Seismic Hazards Public Meeting

Frankie Pimentel, NEI
John Richards, EPRI
Brett Titus, NEI

November 29, 2022

Screening Flowchart

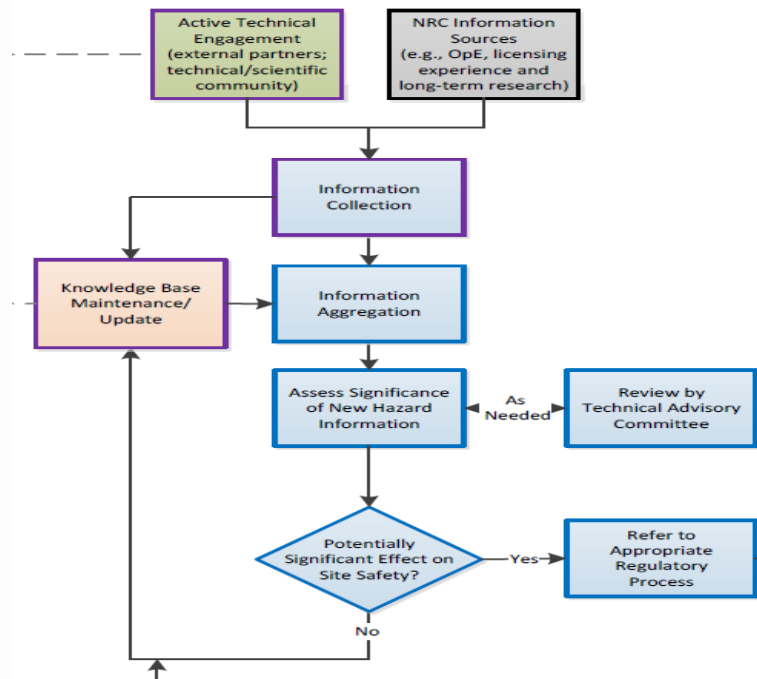
- Attributes of the POANHI framework discussed in SECY-16-0144
- NRC's proposed screening framework, including observations and technical questions regarding screening flowchart criteria
- Review hazard report template
